**ADDENDUM #1
JANUARY 8, 2014**

**MOSS ROAD IMPROVEMENTS
Bid # ITB-002/14/BF**

This Addendum No. 1 to the Contract Documents for City of Winter Springs project "Moss Road Improvements" is hereby declared a part of the original Contract Documents dated December 2013, and in the case of conflict, the following Addendum No. 1 shall govern. **Bidders shall acknowledge receipt of this Addendum on the Bid Form.**

Miami Curb Detail

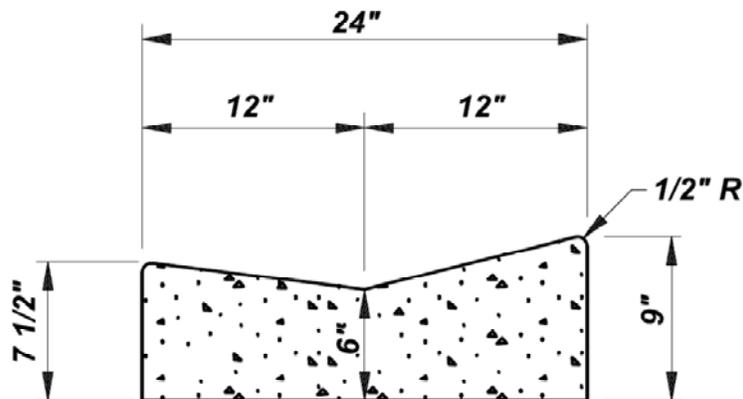
- a. Added pay item #35, "Remove and Replace Existing Miami Curb" and added a corresponding pay item note

20	Brick pavers shall be McNear - Old California Series in Red Hills color, or approved equal. Line item includes leveling sand
35	Remove and replace existing 24-inch Miami curb at various locations on Moss Road as directed by the City. The segments to be replaced will be at least 10-feet long. Miami curb shall be per the detail shown in Addendum 1.
